January 26th, 2017  
Peru State College, Theatre and Event Center Renovation and Addition  
Peru, Nebraska

-----  
**ADDENDUM**

**S7 SECTION @ HP-130a thru HP-130g (BASE BID)**  
M3.2 1/4" = 1'-0"

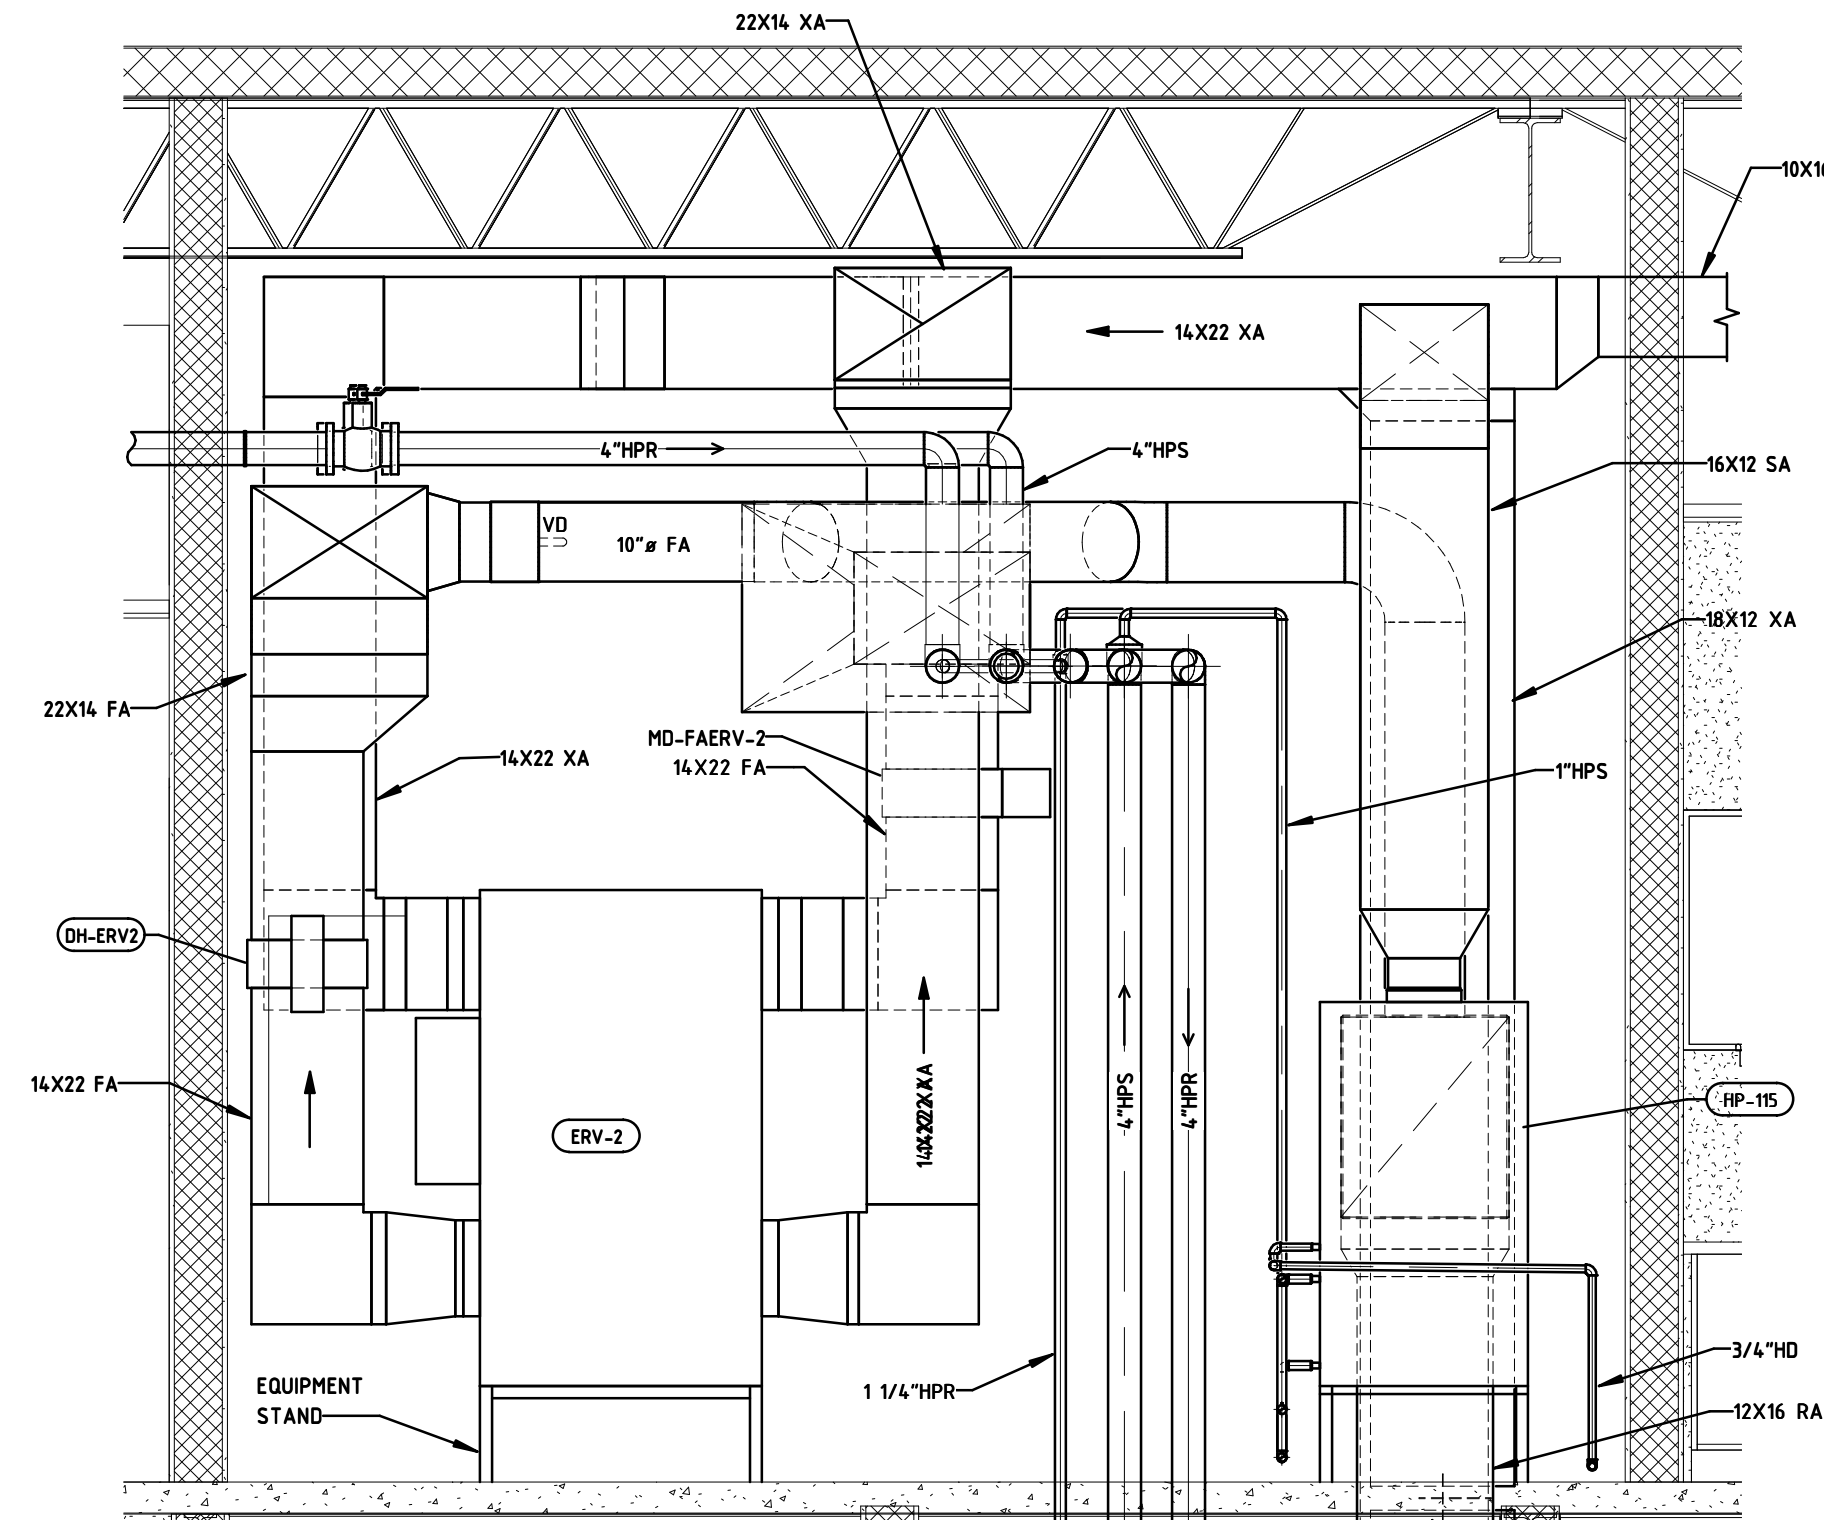
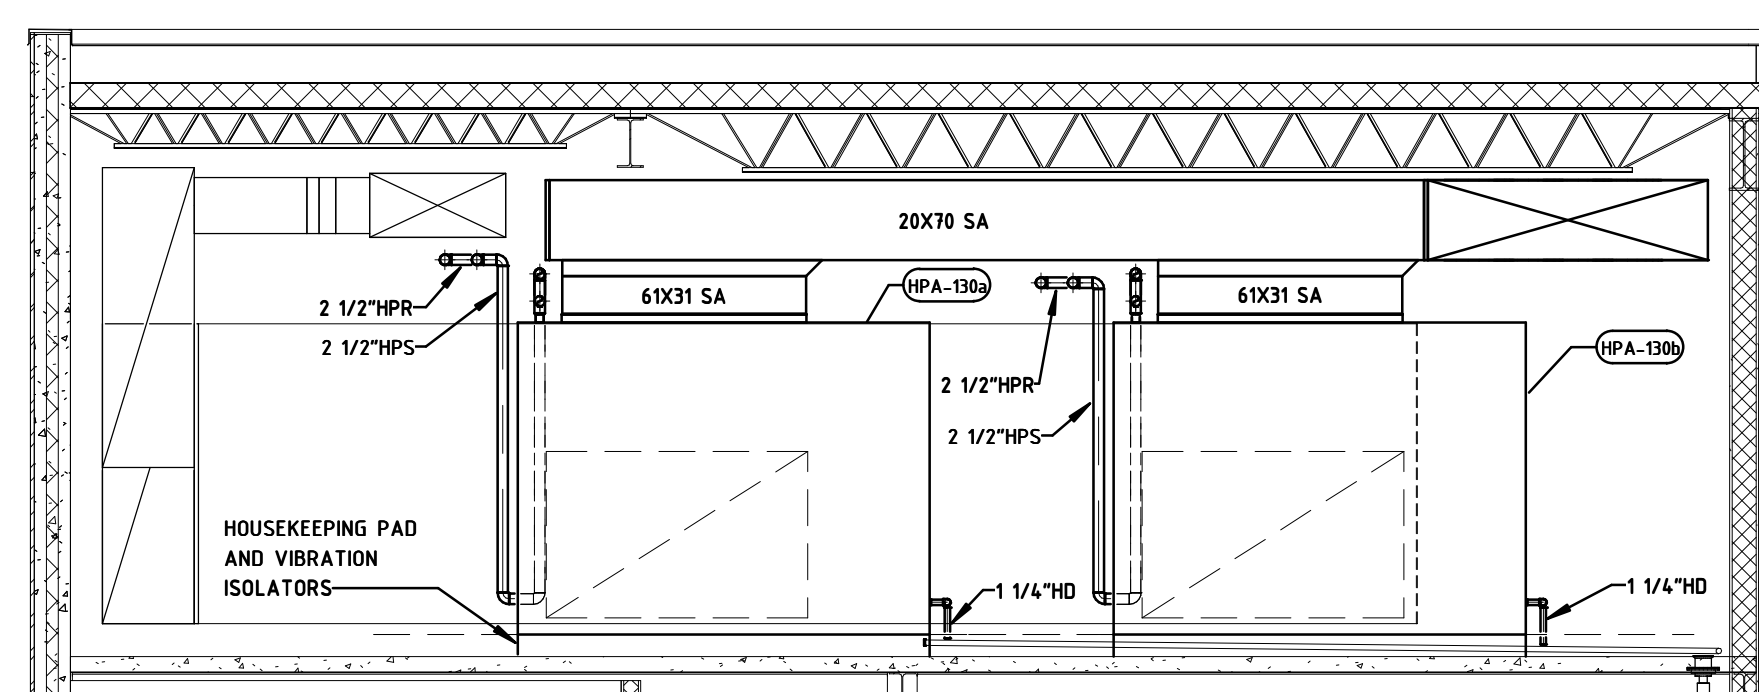
- 1) Add Volume Damper (VD) in 16x20 SA duct of HP-130a thru HP-130g.

**P2 PARTIAL HVAC PLAN - MECH 210 (BASE BID)**

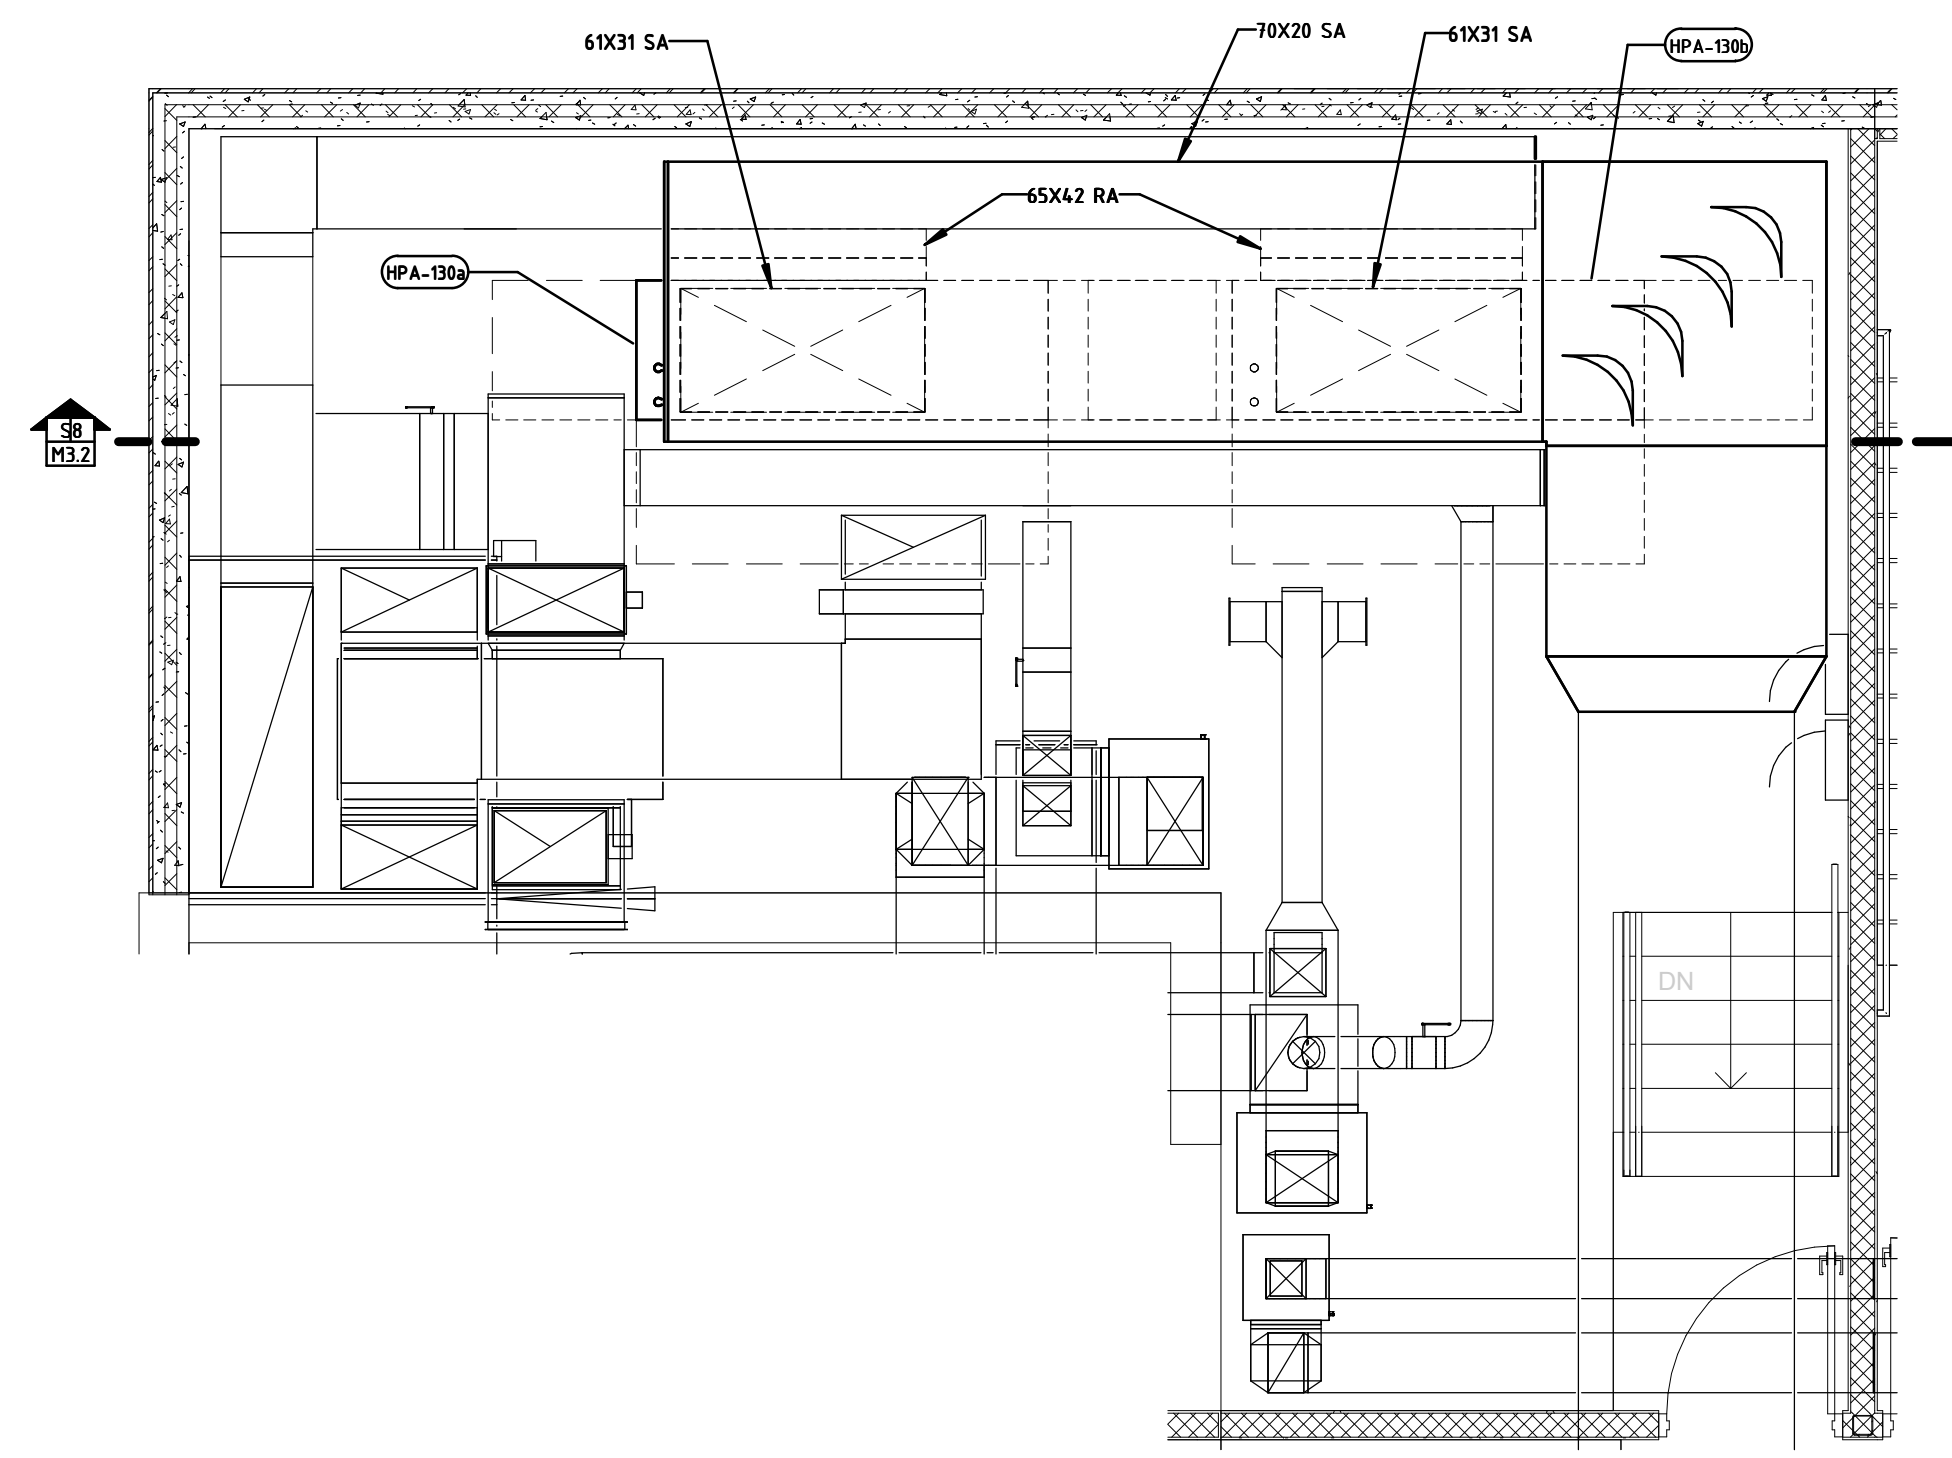
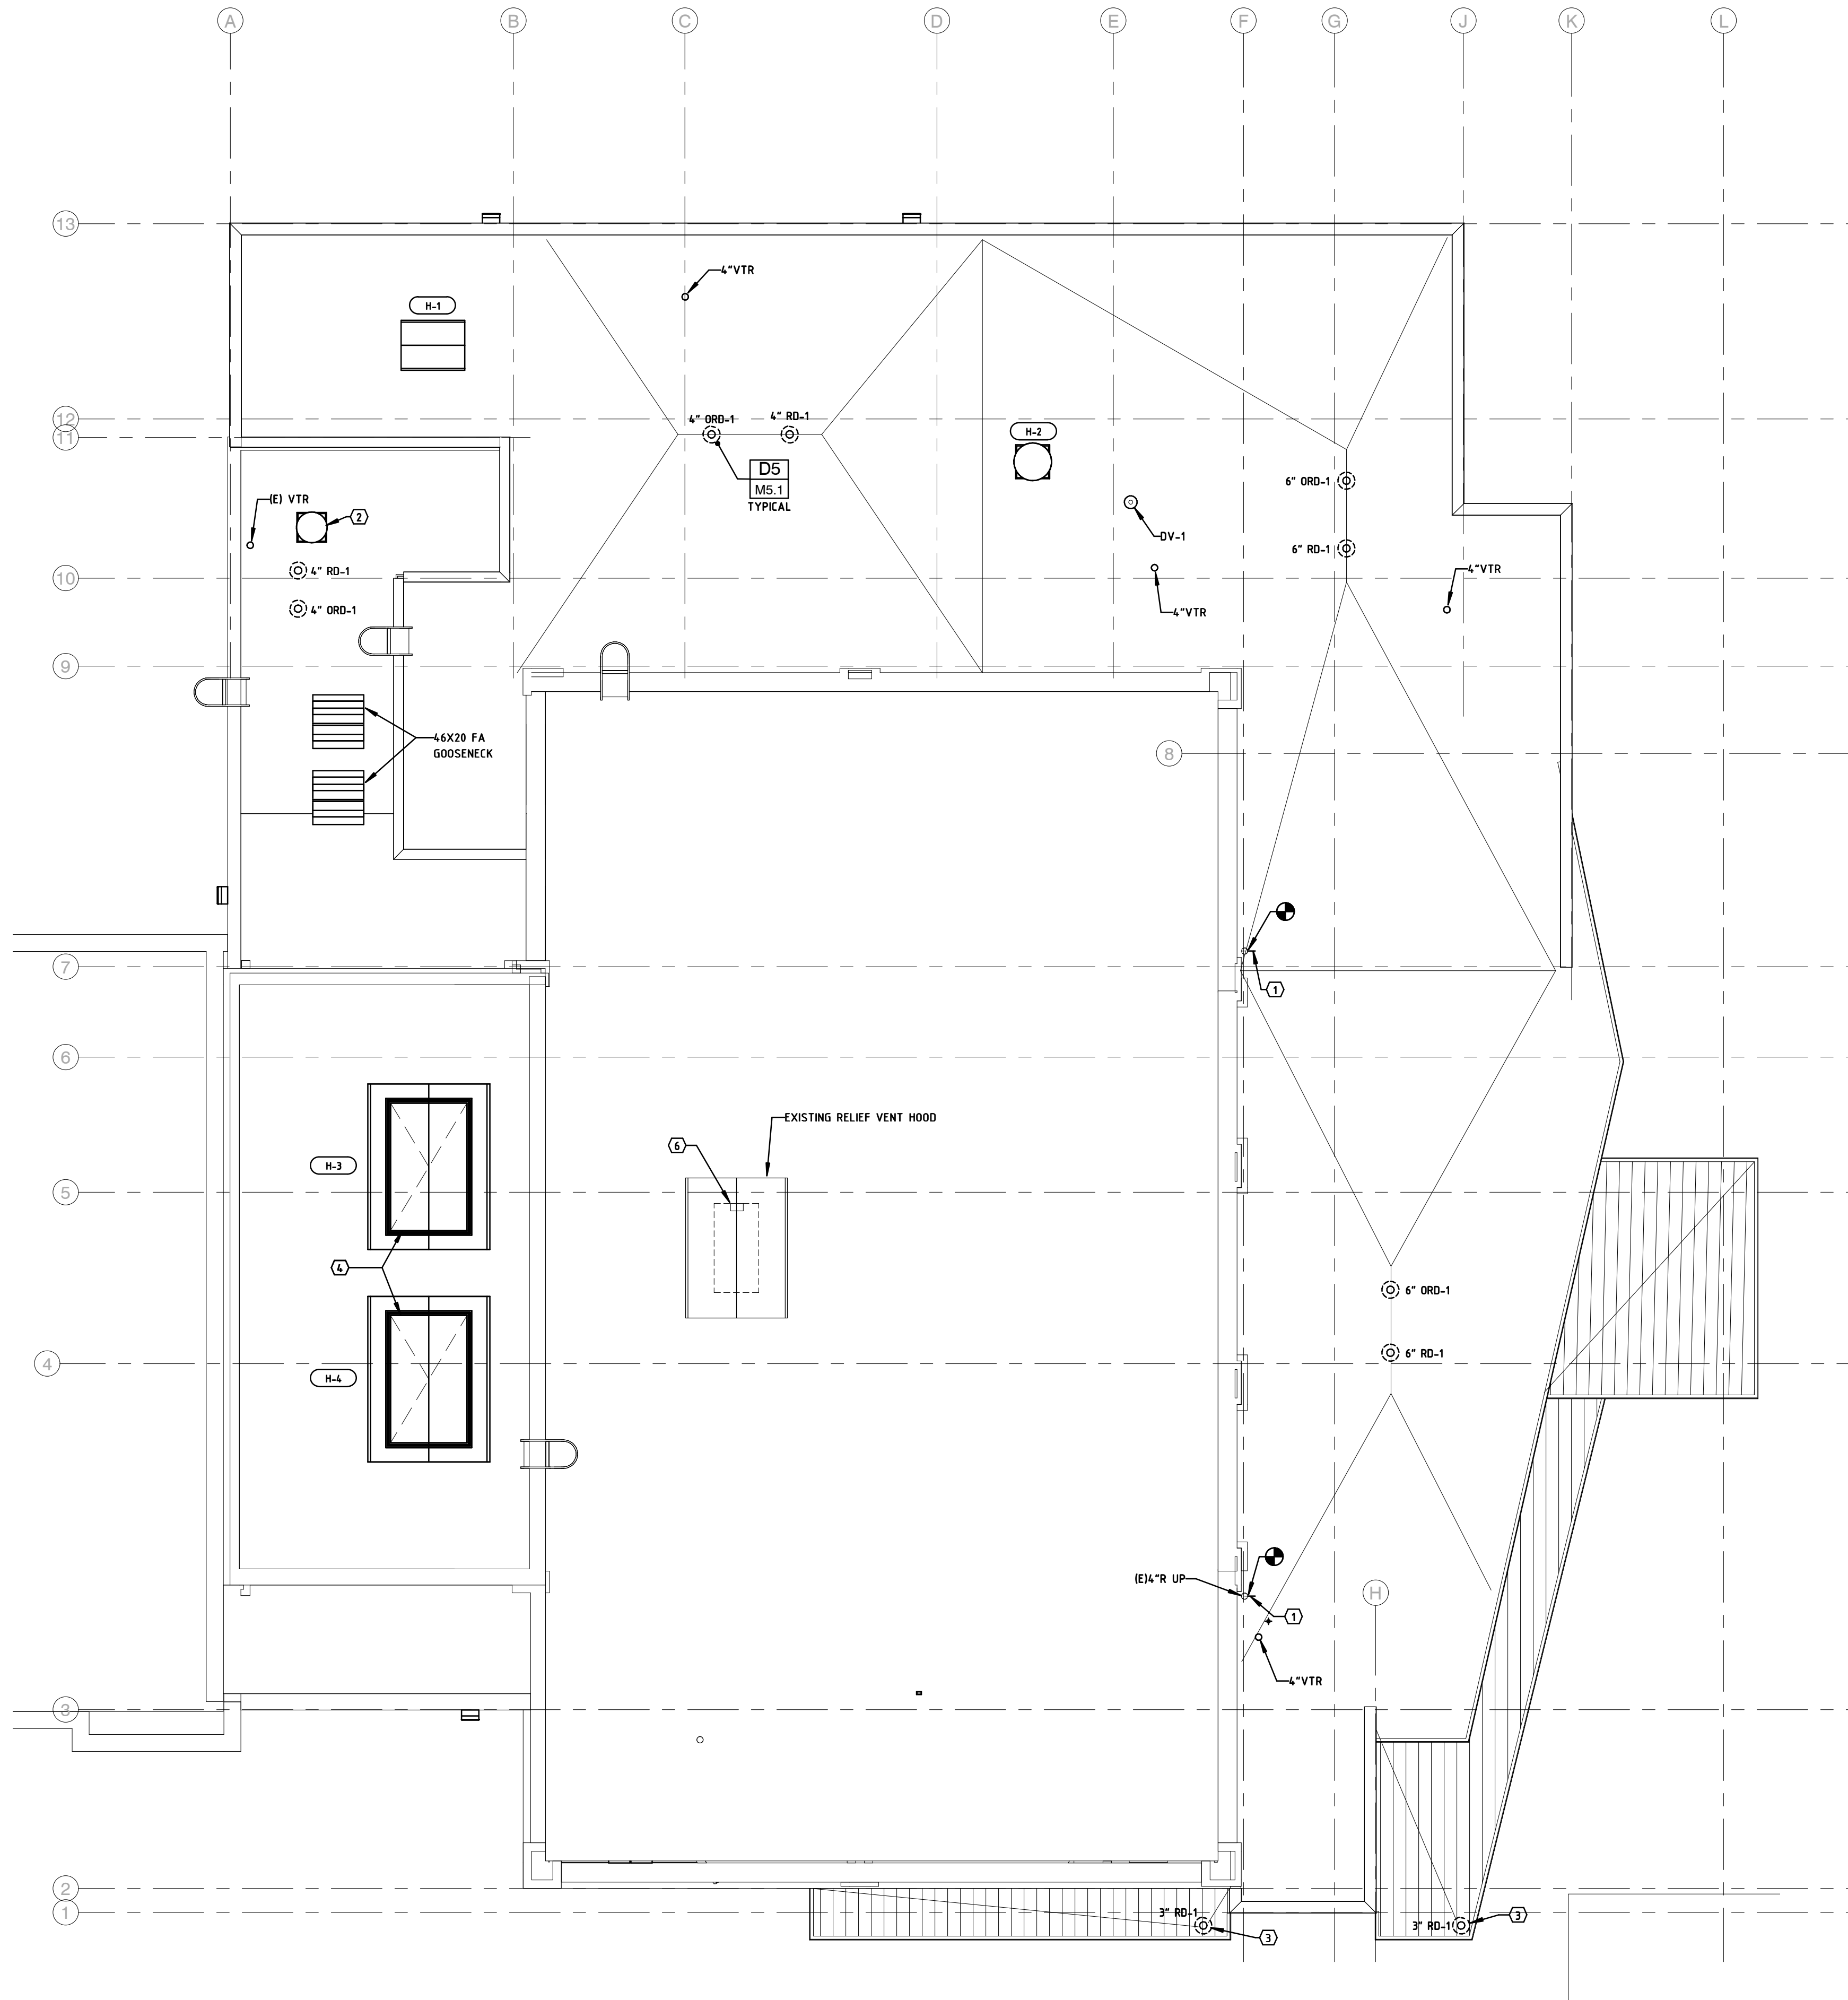
**A. PARTIAL HVAC PLAN – MECH 210 (BASE BID)**

- 1) Added duct size tags.

**B. PARTIAL HVAC PLAN – MECH 210 (ALTERNATE)**

- 1) Added duct size tags.
